SEWAGE DISPOSAL SYSTEM
HOWARD COUNTY HEALTH DEPARTMENT
BUREAU OF ENVIRONMENTAL HEALTH
410-313-2640

SUBDIVISION Vineyards @ Cattail Creek LOT NUMBER 4 ADDRESS 3571 Willow Birch Drive

SITE PLAN FOR
 # 3571 WILLOW BIRCH DRIVE
 LOT #4 OF VINEYARDS AT CATTAIL CREEK
 TAX MAP NO. 21 PARCEL NOS. 21220
 4TH ELEC. DIST. HOWARD CO., MARYLAND
 SCALE: 1" = 40' DATE: 6-23-2000

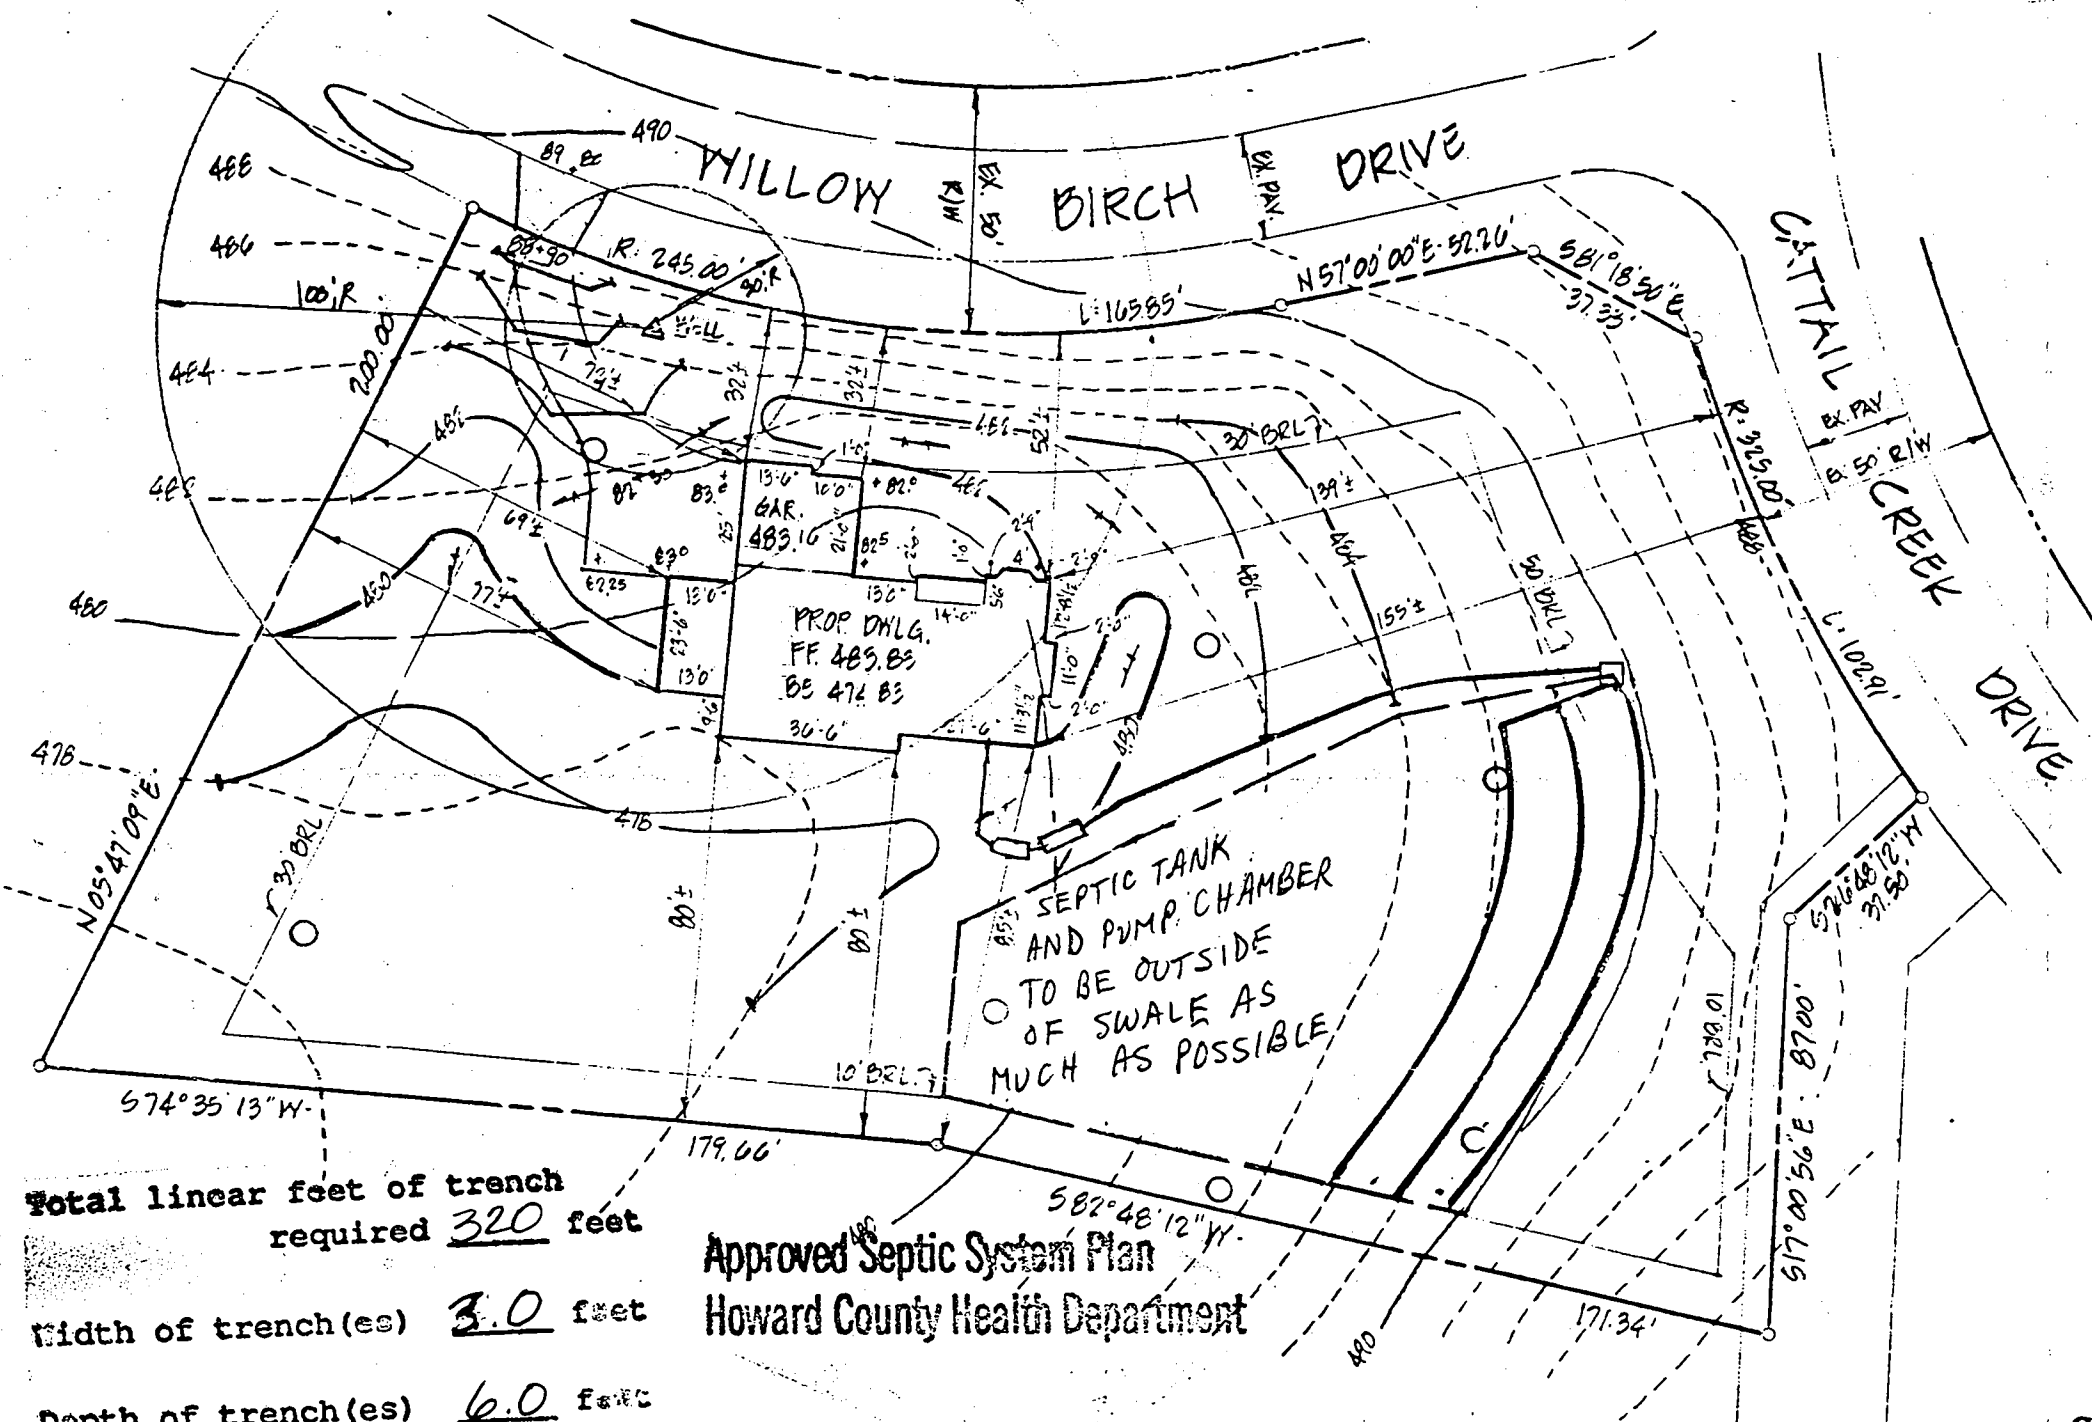
PRE-CONSTRUCTION INSPECTION: Septic Tank and pump chamber were set too deep for landscape position. Soil type is a Glenville with gray layer @ 3 1/2 ft below grade + fragiles @ 2-3 1/2 ft below grade. This level is above top of Tanks. So Contractor will apply extra cement + caulk to ensure lines and inlet points + lids are as water proof as possible. Site will be slightly graded down to Manhole lids. Initial Trench site is staked on level. OK to proceed 11/3/00
INSPECTION COMMENTS:

House Connection OK (under footers) 11/3/00

11/22/00 TRENCHES APPEAR TO

BE COVERED, NO ONE PRESENT (MR)

6/22/01 TRENCHES UNDER 2-3' FILL; POSSIBLY w/PIPE SHALLOW RELATIVE TO ORIG GRADE; NO IMPROVEMENT POSSIBLE - ACCEPTED AS INSTALLED. HOLD FOR PUMP/ALARM (MR)

8/9/01 Pump not working - wired on 110 volt instead of 220 volt. →

* Pump and alarm not on separate circuits. Pump and alarm circuits must be separate. * (BB)

8/17/01 Pump and alarm working.. (BB)

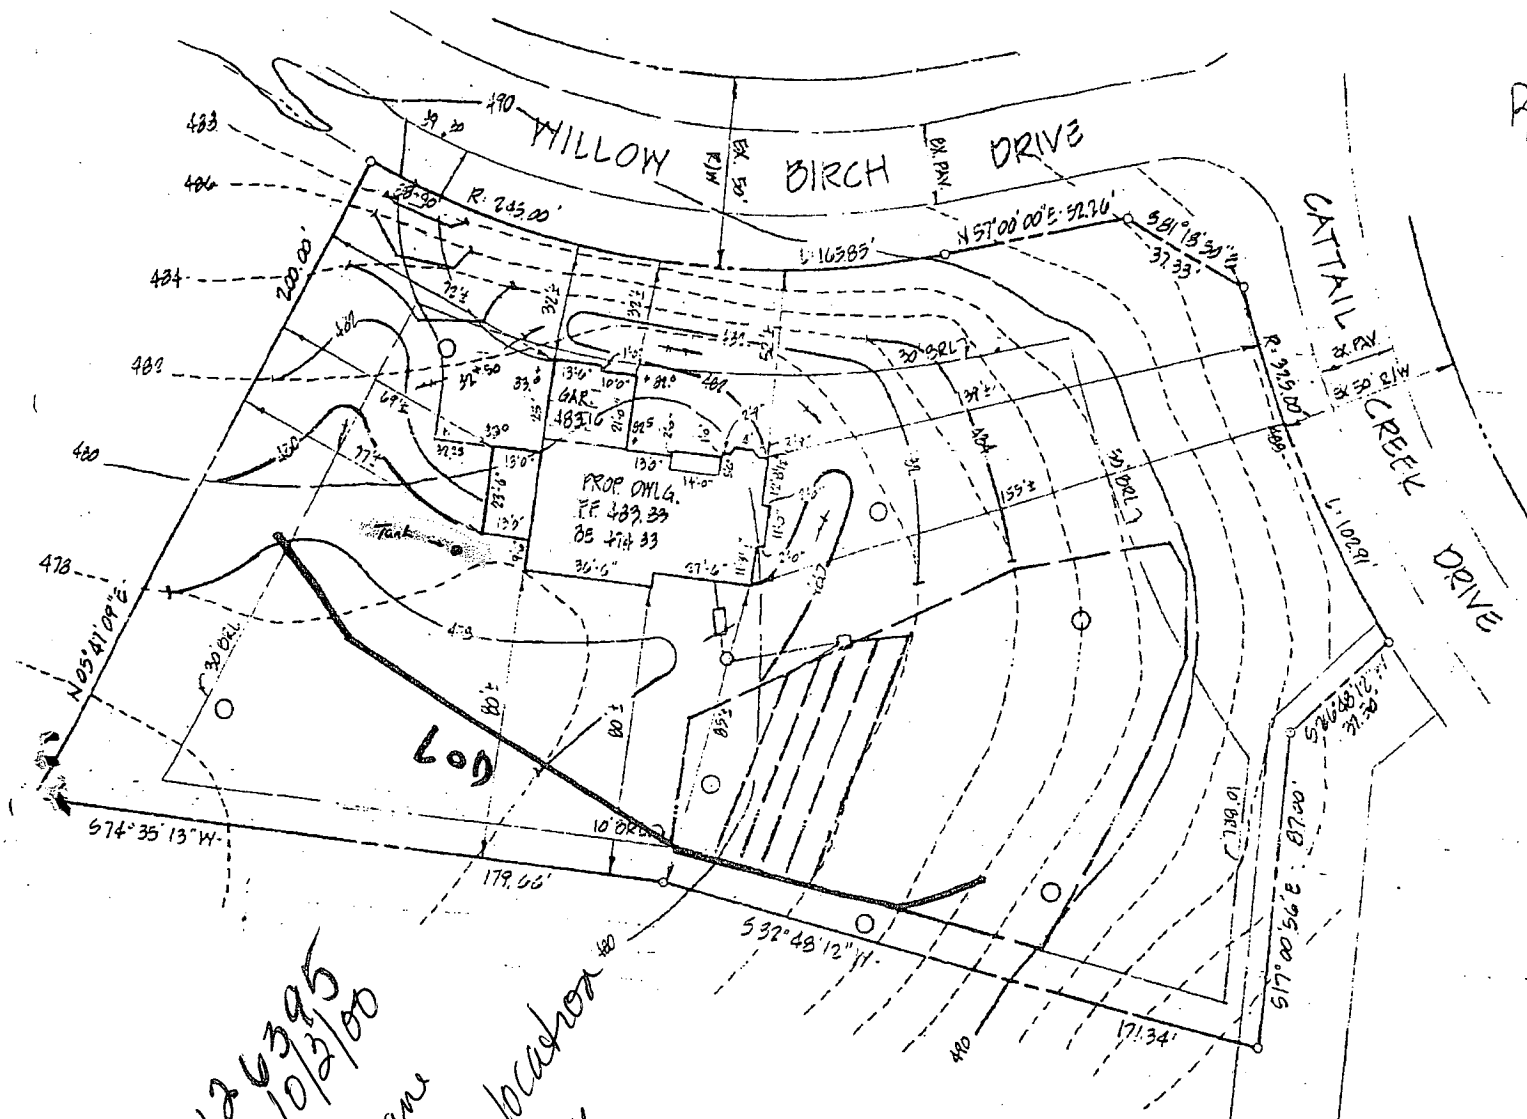
Because 320' of trench may take up more than 1/3 of the septic easement, edge to edge requirements should be specified in field during preconstruction inspection - SRN
